Chapter Nine

GEOLOGY

Introduction:

ROCKERY WALL
TYPICAL SECTION
N.T.S.

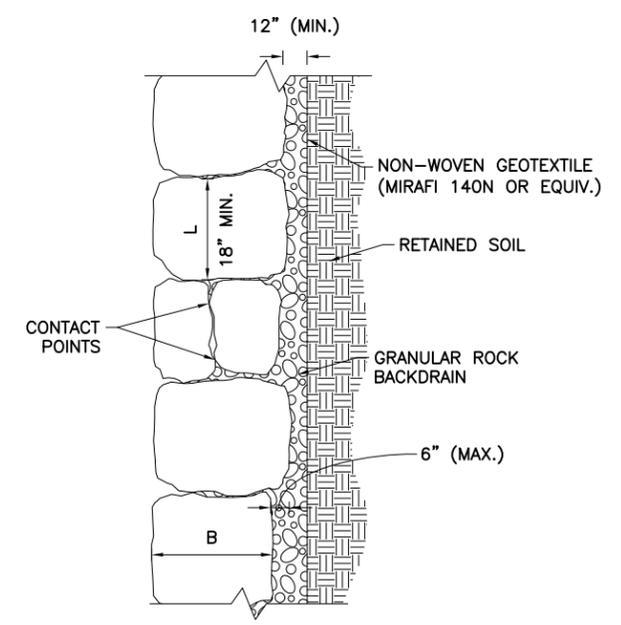
- 1. As previously noted, geotechnical details of design for retaining walls and manufactured 2:1 (two horizontal to one vertical) slopes should be provided. (NLJA (11/12/2013))*

The full construction details of the site retaining walls have not been finalized at this early stage of the project, but the sketch included at the end of this chapter depicts the typical geometry and construction of the proposed fill sloped embankment and boulder walls. As seen on the sketch the fill slope will be constructed at 2H:1V (horizontal to vertical), above three 10-foot high tiered boulder walls. Each boulder wall will be separated from the adjacent wall by a ten-foot distance. The bench between each wall will be planted with a dense ground cover, noninvasive vine, shrub, or ornamental trees and be sloped so as to shed water. The batter of the boulder walls (based on the sketch provided at the end of this chapter) will be approximately 1H:4V, and the slope of the berms will be about 5H:1V. Preliminary analyses were performed to determine that the proposed slope and boulder walls will be stable (at the proposed locations and proposed slope/wall heights and geometries).

Regarding the 2H:1V slopes, their design is typical and will require use of non-organic granular materials placed in lifts and compacted to a minimum of 92% of Dry Density, or if rock fill is used, the project's specifications will specify detailed means and methods to place the rock-fill materials in maximum lift thicknesses that match the compaction equipment sizes/weights and a minimum number of passes (four in each direction) to achieve the required strength and stability. Gradation requirements will also be provided for the choker layer material at the top of rock fill materials and below the building pad

Final design of manufactured slopes and retaining walls will be provided by the project Geotechnical Engineer and reviewed during the application for site plan approval.
